ORDINARY COUNCIL MEETING

Form 1: Responsible Authority Report

LOT 504 (NO. 5) HARDISTY COURT, PICTON EAST – CONVERSION OF DIESEL GENERATION POWER STATION TO A BATTERY ENERGY STORAGE SYSTEM (BESS)

| DAP Name: | Regional DAP |
|---|--|
| DAP File No: | DAP/24/02653 |

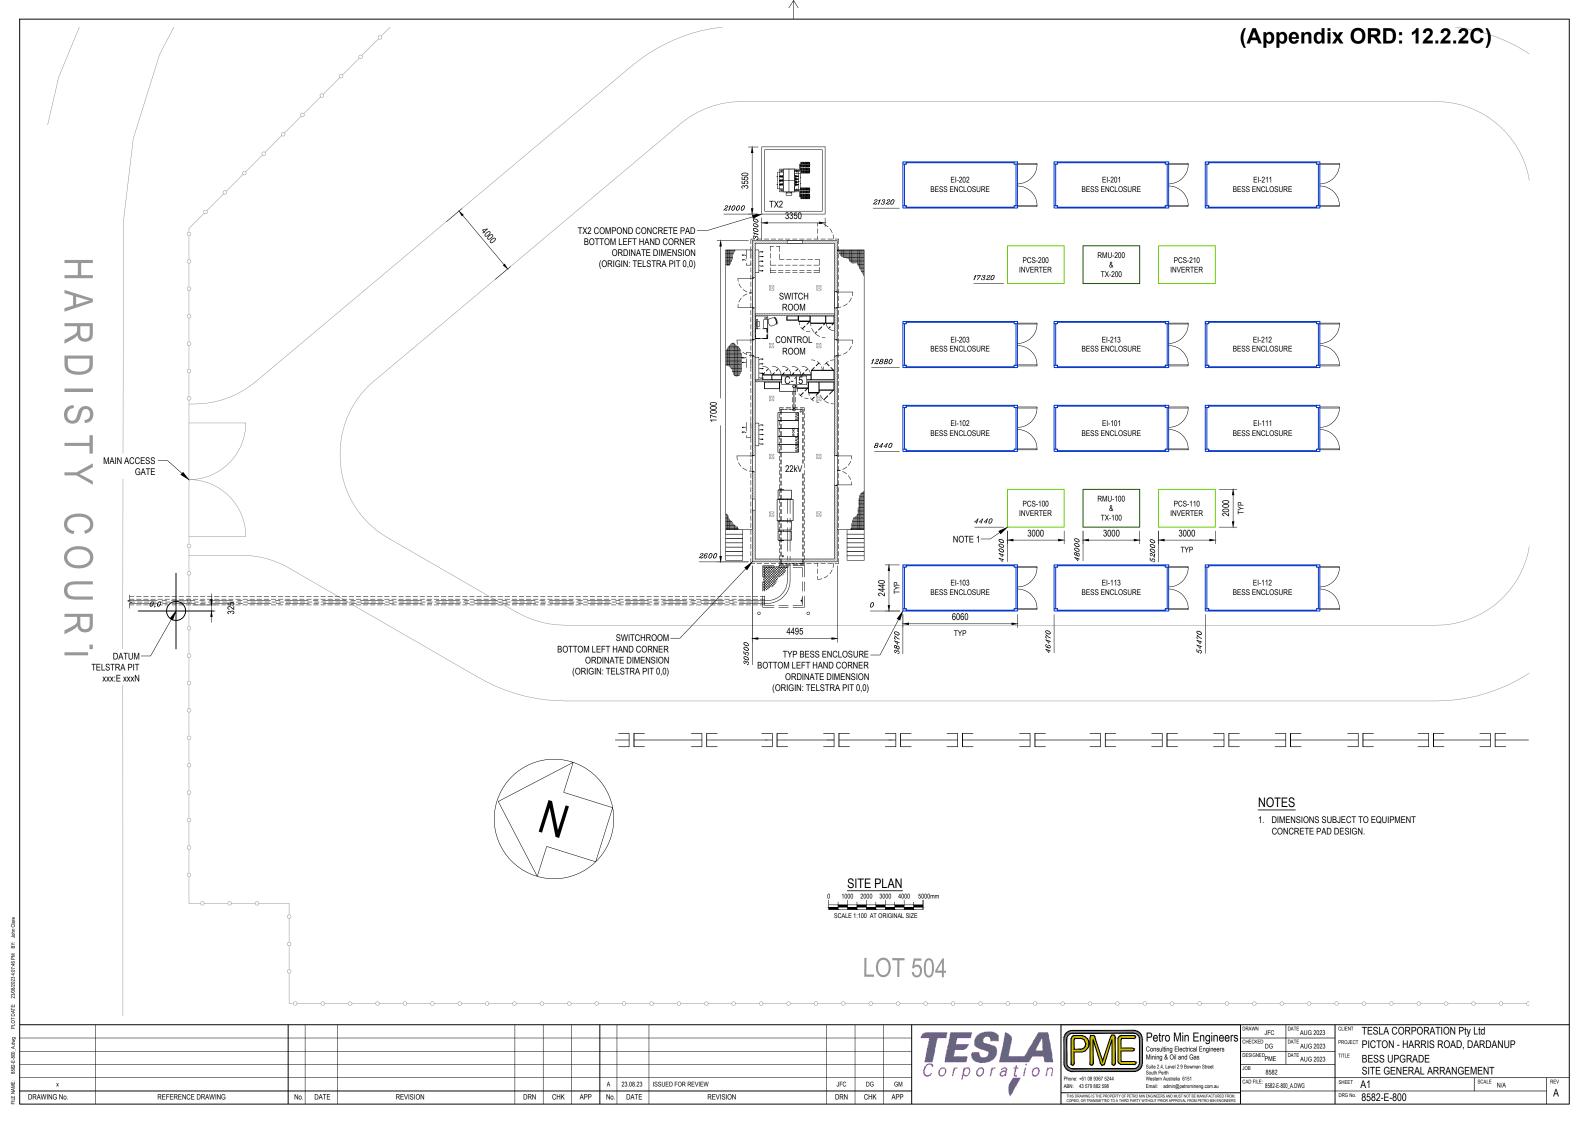
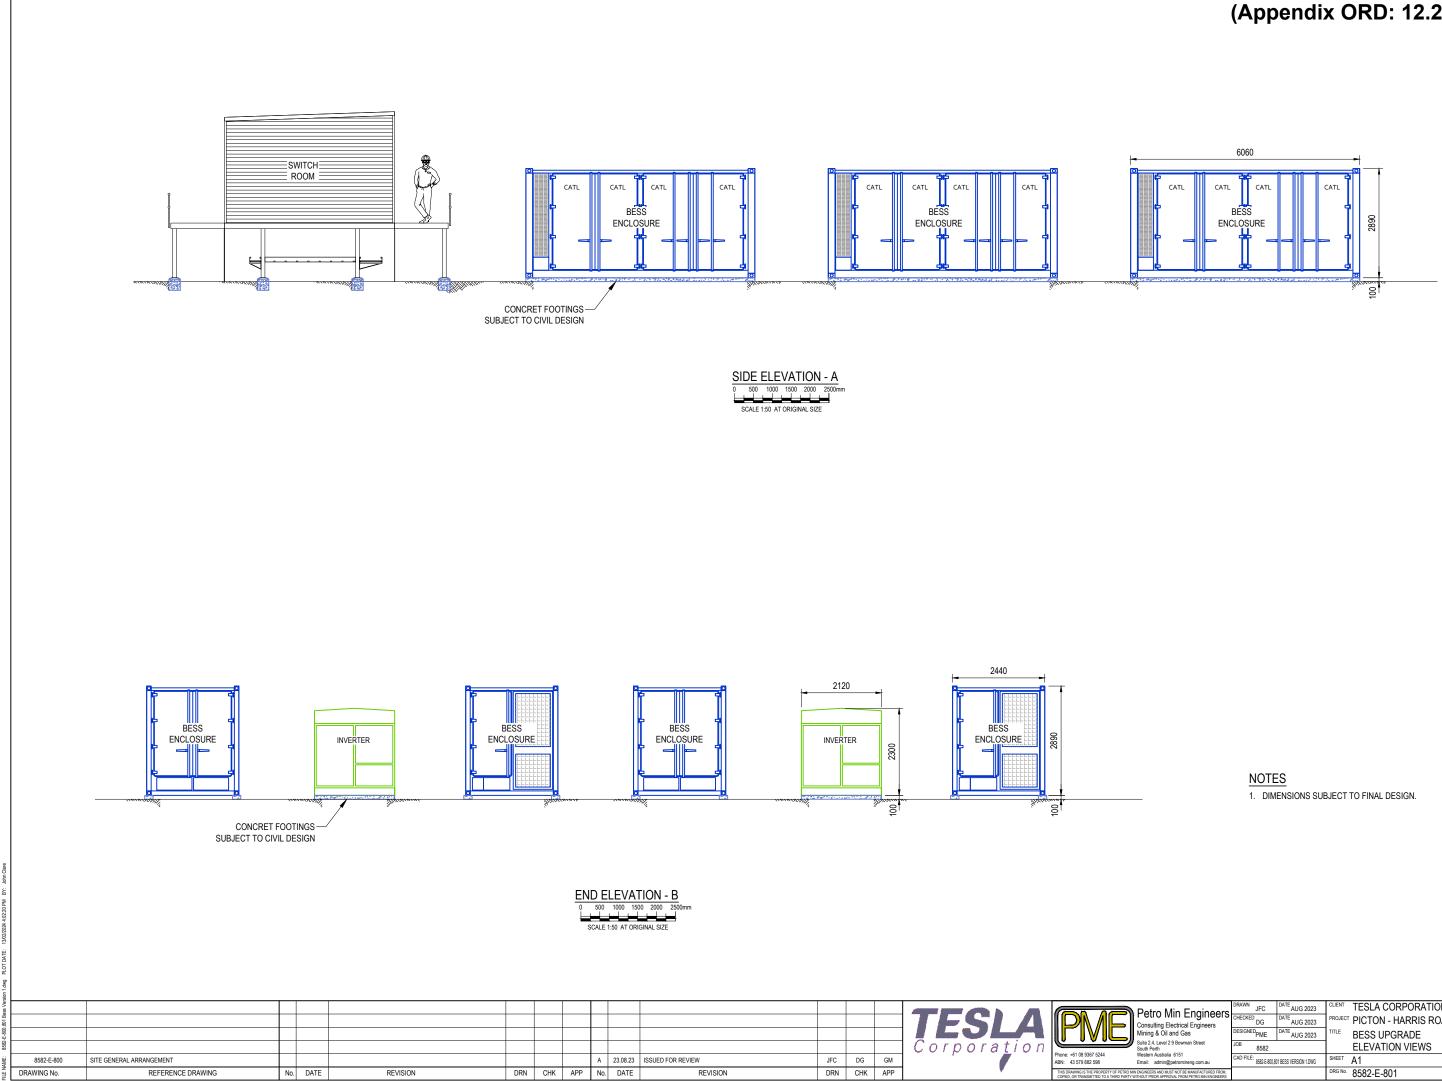
- 2. Prior to the operation of the development Drawing No. 8582-E-800, Rev A being amended and submitted to the satisfaction of the Shire of Dardanup showing the sealed crossover width to be 6m.
